SUPREME COURT OF THE STATE OF NEW YORK  
COUNTY OF NASSAU

**AFFIDAVIT**

2. I personally reviewed the hydrologic aspects of the Hempstead Lake State Park Project ("Project") being undertaken by the Governor's Office of Storm Recovery ("GOSR"). While the Hempstead Lake State Park Project Environmental Assessment ("EA") provides certain base-line information related to hydrologic aspects of the Project, it severely lacks critical information and analyses on how each of the impacts of Project actions will cumulatively affect other actions when completed, the very thing the EA is supposed to include.

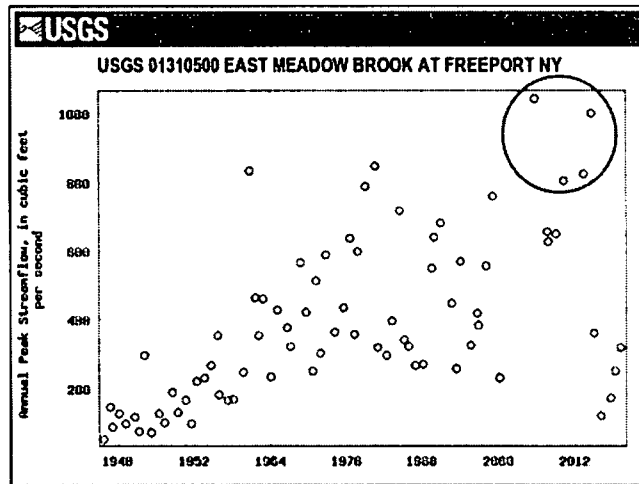
12. Additionally, climate change may result in increased precipitation quantities and increased flood frequency. For example, the USGS peak flow data recorded at the East Meadow Brook gaging station (figure above) indicates a number of increasingly high annual peak discharges in recent years. The plot of the USGS annual peak flow data shows that some of the highest discharge events have occurred in recent time (circled area).
